INDESIT company

Model type:
IDC73EU

Commercial code:
F066185

07427-20 Exploded views

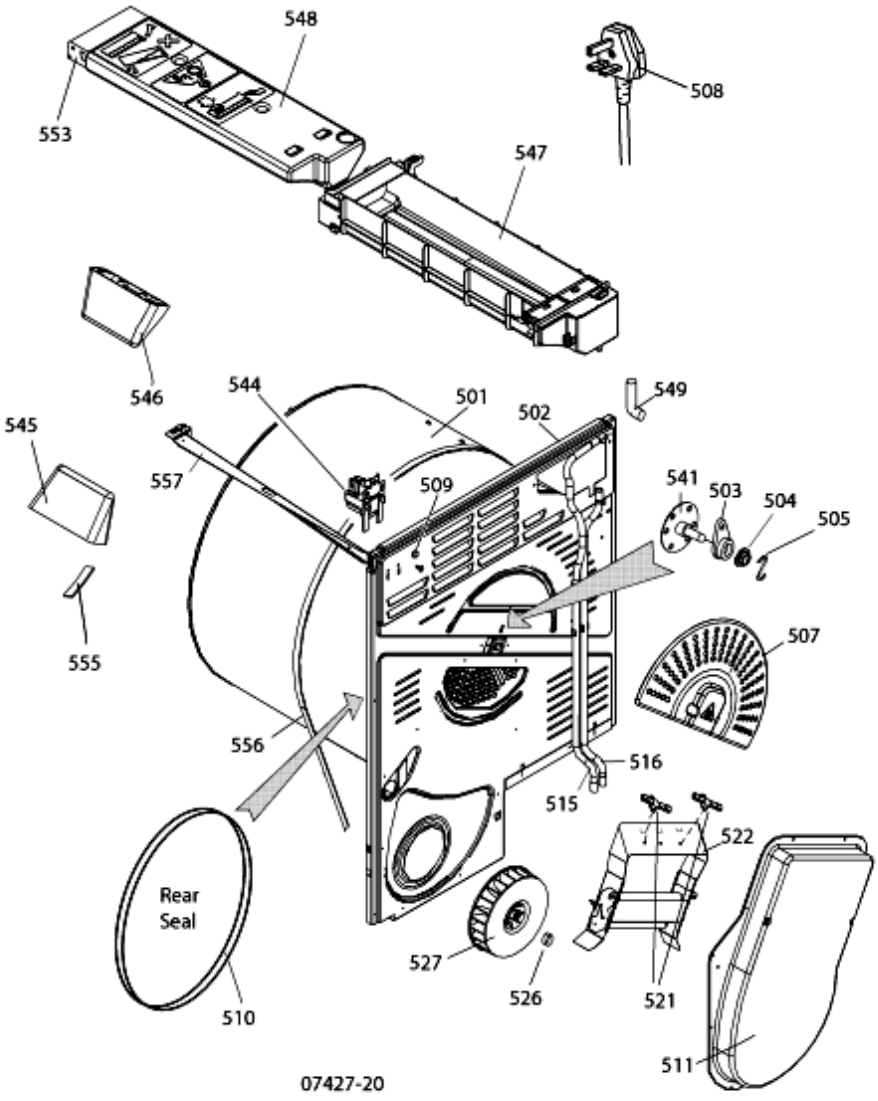
n4409a00: DRUM SHAFT

Two Drums have been used in production.

Inspect the machine to see which type of drum shaft fixing is fitted.

1 has a drum shaft which is screwed and the shaft only can be replaced if required.

1 has a drum shaft which is fixed and the shaft can not be replaced, if damaged the complete drum assembly will be required.

n4410k02: TUMBLE DRYER HEATER CHANGE

FROM SERIAL NUMBER 01112.0000 A NEW HEATER WITH A COLOMBO CONNECTOR HAS BEEN USED IN PRODUCTION.
THIS NEW HEATER IS NOT INTERCHANGEABLE WITH THE PREVIOUS ONE.

n4411j00: PATTERN DRUM INTRODUCED

FROM OCTOBER 2011 A PATTERN DRUM HAS BEEN USED IN PRODUCTION.
THE PATTERN DRUM IS INTERCHANGABLE WITH THE PREVIOUS PLAIN DRUM.
ONCE STOCKS OF THE PLAIN DRUM ARE EXHAUSTED.
THE PATTERN DRUM WILL BE THE SERVICE SPARE.

NOTE
TWO PLAIN DRUMS WERE USED IN PRODUCTION.
THE DRUM SHAFT CAN ONLY BE REPLACED IF THE ORIGINAL DRUM TO SHAFT FIXING IS SCREWED. IF THE DRUM SHAFT IS RIVETED TO THE DRUM, THE COMPLETE DRUM HAS TO BE REPLACED.

n4414g00: DRUM SHAFT REPAIR KITS

THERE ARE 2 TUMBLE DRYER DRUM SHAFT KITS.

C00113038 DRUMS WHERE THE DRUM SHAFT IS SCREWED
C00305794 DRUMS WHERE THE DRUM SHAFT IS RIVETTED.
THE CORRECT KIT MUST ALWAYS BE FITTED.
BOTH KITS CONSIST OF THE DRUM SHAFT/SUPPORT, DRIVE PIN FIXING SCREWS and REAR BEARING.
STARTING FROM JUNE 2014 THE DRUM SEALS WHICH WERE INCLUDED IN KIT C00113038 HAVE BEEN REMOVED.

n4413j00: BREAKING BELTS

To overcome the issue of breaking belts the 6 Rib belt has been replaced by the 8 rib belt C00300793

07484-06 Exploded views

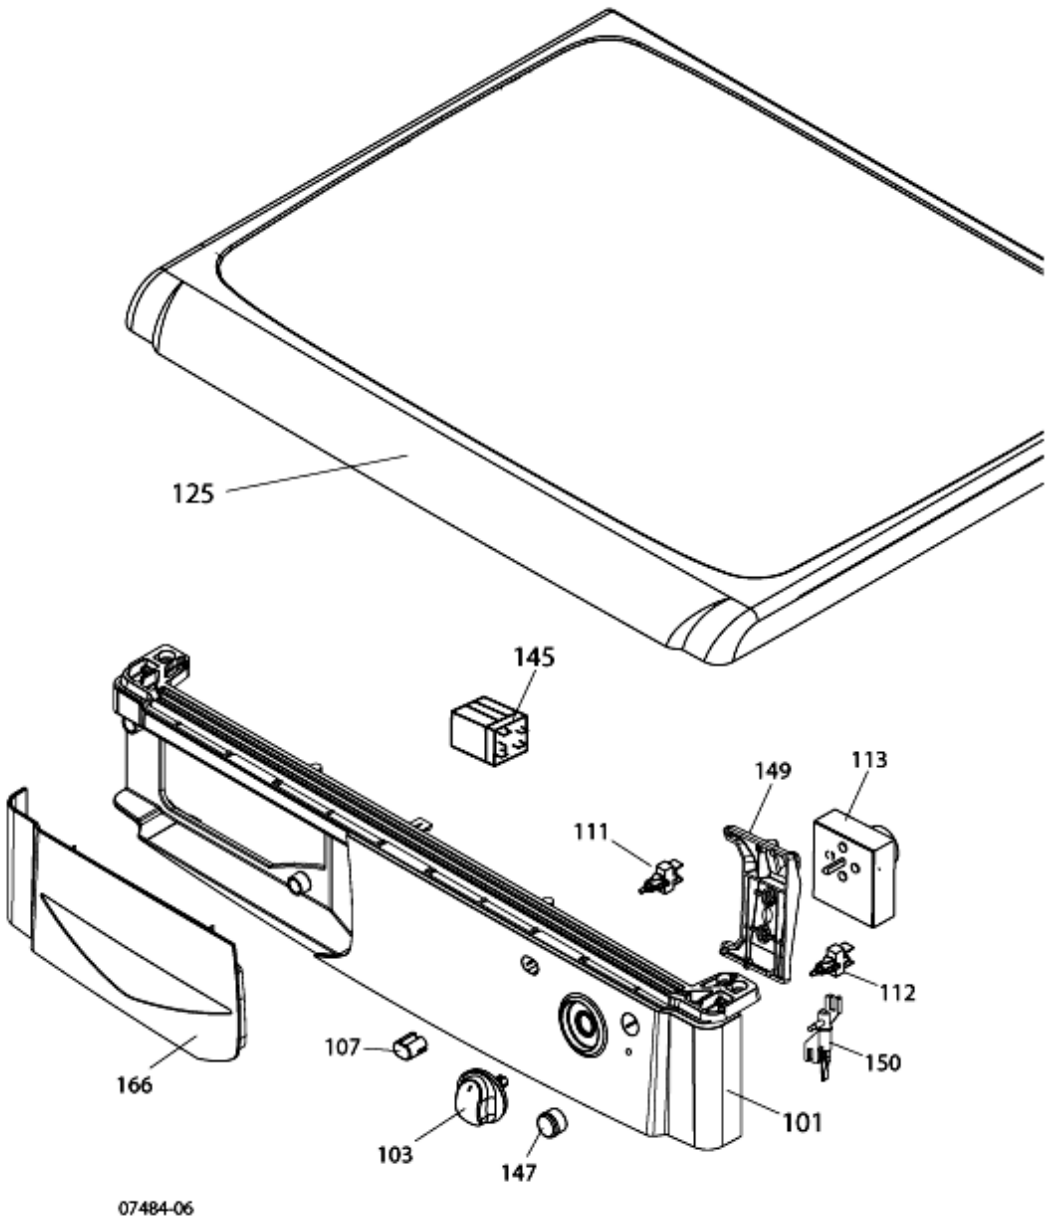
n4411i00: CONDENSER REVERSING TIMERS

2 TIMERS HAVE BEEN USED IN PRODUCTION. INVENSYS AND BITRON (ELBI).
CHECK THE TIMER FITTED TO THE MACHINE BEFORE ORDERING.

THE TIMERS ARE INTERCHANGEABLE, BUT THE TIMER CONECTIONS ARE LABELLED DIFFERENTLY.
THE ALTERNATE WIRING CONNECTIONS ARE SHOWN IN THE WIRING DIAGRAM FOUND IN THE SERVICE MANUAL OR WIRING DIAGRAM.

12721-15 Exploded views

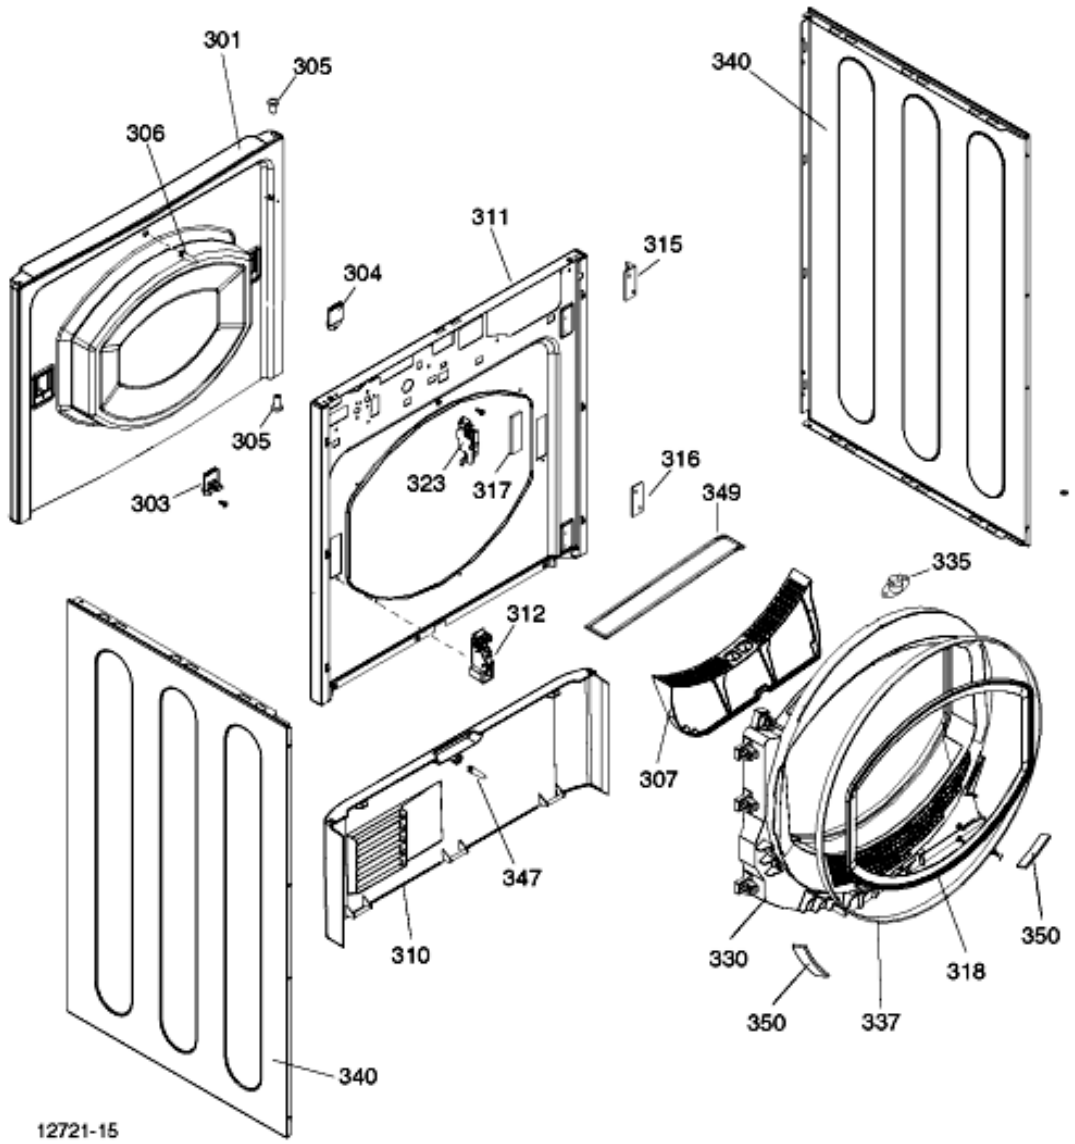
n4409i01: Bearing Pad Grooved

'C' Energy Condenser Tumble Dryers.
From serial number 90817.0001 the quantity of bearing pads C00255284 fitted on production was reduced fro 5 to 4.
'B' Energy Condenser Tumble Dryers are not effected and will continue to use 5 bearing pads

n4411g00: CONDENSER DRYER DOOR SEALS

ON SELECTED TUMBLE DRYERS FROM JUNE 2011 THE DOOR SEAL COLOUR CHANGED FROM GREY TO WHITE.
SELECTED THE CORRECT PART BY DESCRIPTION IN THE PARTS LIST

n4411g07: CONDENSER FRONT AIR DUCT COLOUR CHANGE

FROM JUNE 2011 THE FRONT AIR DUCT FITTED TO CONDENSER TUMBLE DRYERS CHANGED IN PRODUCTION FROM GREY TO WHITE.
SELECTED THE CORRECT PART BY DESCRIPTION IN THE PARTS LIST

n4414b02: DOOR RELAY REPLACED IN PRODUCTION

DURING OCTOBER 2013 THE DOOR RELAY AND ASSOCIATED DOOR SWITCH FITTED TO CERTAIN TUMBLE DRYERS IS NO LONGER USED IN PRODUCTION.
A BITRON DOOR SWITCH/LOCK ASSEMBLY REPLACES THE ORIGINAL DOOR RELAY AND DOOR SWITCH.
NOTE DURING OCTOBER 2013 THE TYPE OF DOOR LOCK WILL HAVE TO BE VISUALLY IDENTIFIED AS BOTH THE ORIGINAL DOOR LOCK AND RELAY AND THE BITRON DOOR SWITCH/LOCK HAVE BEEN USED IN PRODUCTION.

n4414a03: BEARING PADS REDUCED

FROM JUNE 2013 THE NUMBER OF BEARING PADS FITTED IN PRODUCTION WAS REDUCED FROM 5 to 4.
FROM THIS DATE THE LEFT HAND BEARING PAD (WHEN VIEWED FROM THE FRONT) IS NO LONGER FITTED
